Access Compliance Report Public Rights-of-Way (Curb Ramps)

Main Street: ST_STEVEN_CT Cross Street: ST_BRIDE_WAY Location: E

ADA ID: RPRK211110133147 Ramp Type: Type 4 - Parallel Initial Pass/Fail: Pass Overall Compliance: No Severity Score: 22

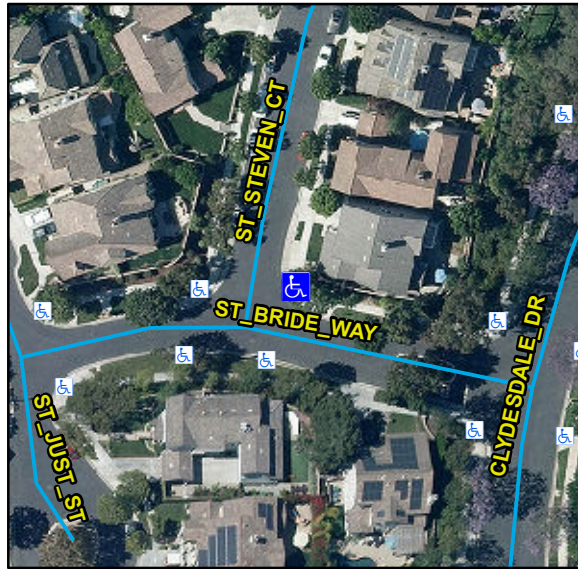
Compliance	Description	Data	Compliance	Description	Data
N/A	Ramp Length LT (in)	136	N/A	Ramp Length RT (in)	137
Yes	Ramp Width LT (in)	53	Yes	Ramp Width RT (in)	53
Yes	Ramp Run Slope LT (%)	6.8	Yes	Ramp Run Slope RT (%)	5.5
No	Ramp Cross Slope LT (%)	2.1	Yes	Ramp Cross Slope RT (%)	1
N/A	Landing Present	No	No	DWS Provided	No
N/A	Landing Length (in)	N/A	N/A	DWS Contrast	N/A
No	Landing Width (in)	N/A	N/A	DWS Length (in)	N/A
No	Landing Run Slope (%)	N/A	N/A	DWS Full Width	N/A
No	Landing Cross Slope (%)	N/A		DWS Offset Type	N/A
N/A	Landing Movement Obstructed?	No	N/A	DWS Offset Left (in)	N/A
	Landing Movement Type	Curb	N/A	DWS Offset Right (in)	N/A
N/A	Landing Shared	N/A			
N/A	Clear Space	Yes			
N/A	Clear Space To Crosswalk (in)	48			
N/A	Marked Crosswalk 1	No	N/A	Marked Crosswalk 2	No
	Crossing 1 Direction	NW		Crossing 2 Direction	SW
	Marked Crosswalk 1 Width (in)	N/A		Marked Crosswalk 2 Width (in)	N/A
N/A	Ramp Inside Crosswalk 1	N/A	N/A	Ramp Inside Crosswalk 2	N/A

Crossing 1 Slope (%)	3.8		Crossing 2 Slope (%)	2.2
	Crossing 1 Cross Slope (%)	2.3		Crossing 2 Cross Slope (%)	1
Yes	Gutter Ponding	No	N/A	Curb Slope	4.1
Yes	Gutter Lip Height (in)	0		Road Run Slope (%)	2.2
Yes	Gutter Run Slope (%)	3.7		Road Cross Slope (%)	2.4
No	Gutter Cross Slope (%)	3.2	No	Perpendicular Joint Present	No
Yes	Overall Surface Condition	Acceptable			
	Cross Gutter Present?	No		Spandrel Present?	No
	Replace Cross Gutter?	N/A		Replace Spandrel?	N/A

Remove & Replace Curb Ramp With Two New Directional Ramps or Equivalent. Remove & Replace Gutter.
